SERVICE BULLETIN

ADDITIONAL CAPSCREWS REQUIRED FOR CLAMPING WINDSHIELD
S/N 3 thru 7

SERVICE BULLETIN 91-1

HI-ROLLER - WINDSHIELD

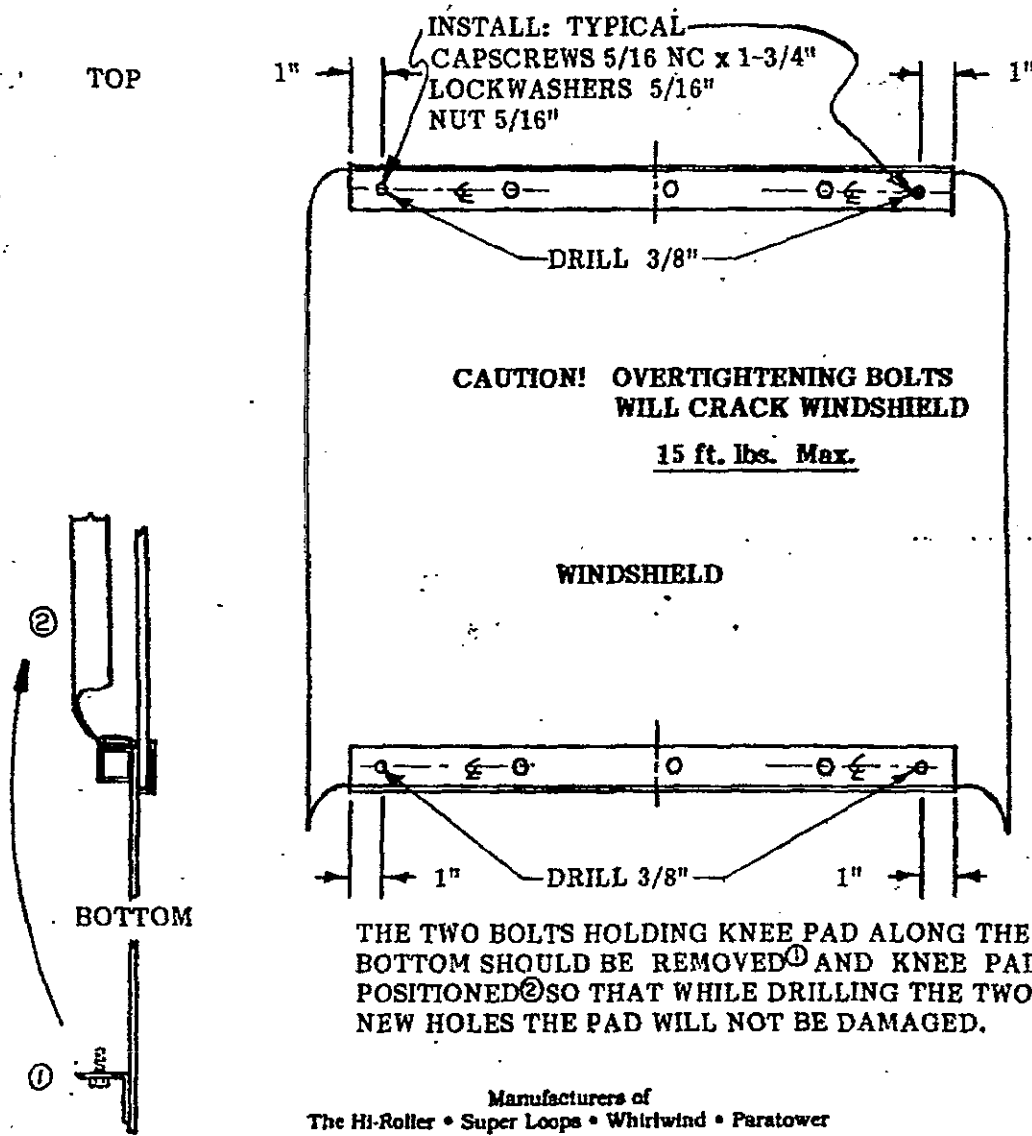
THE TWO BOLTS HOLDING KNEE PAD ALONG THE BOTTOM SHOULD BE REMOVED^① AND KNEE PAD POSITIONED^② SO THAT WHILE DRILLING THE TWO NEW HOLES THE PAD WILL NOT BE DAMAGED.

- 40 EA H101250 CAPSCREWS 5/16" NC x 1-3/4"
- 40 EA H300030 LOCKWASHERS 5/16"
- 40 EA H200030 HEX NUT 5/16" NC
- 2 EA DRILL BITS 3/8"
